BRIDGE RAIL LAYOUT ~ UNIT 2 (SPANS 7 THRU 15)

SHOP DRAWING REVIEW

Job Number: 379200
Reviewed By: JMM
Date: 11/01/05

DETAIL 2
TYPICAL RAIL SPLICE

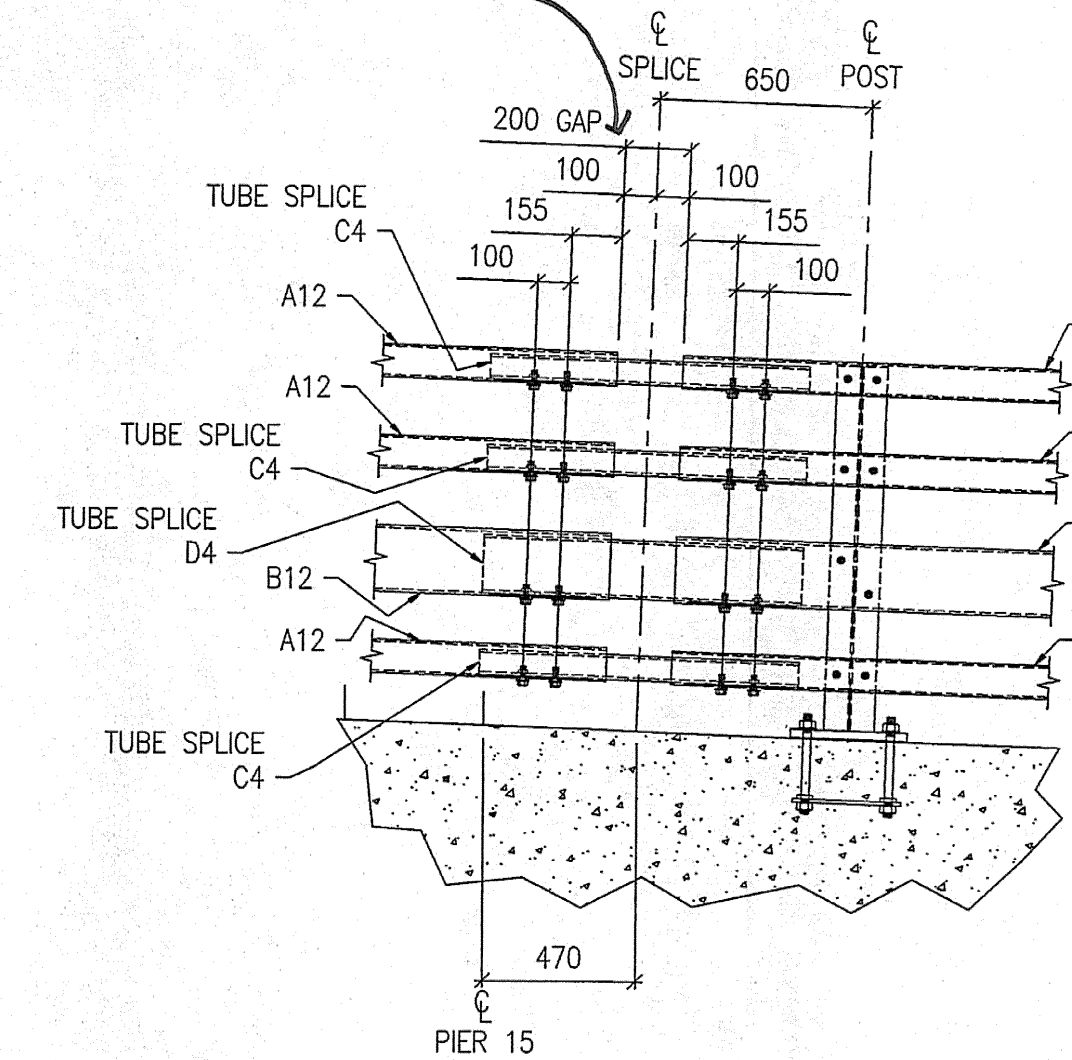
ADD "@70C"
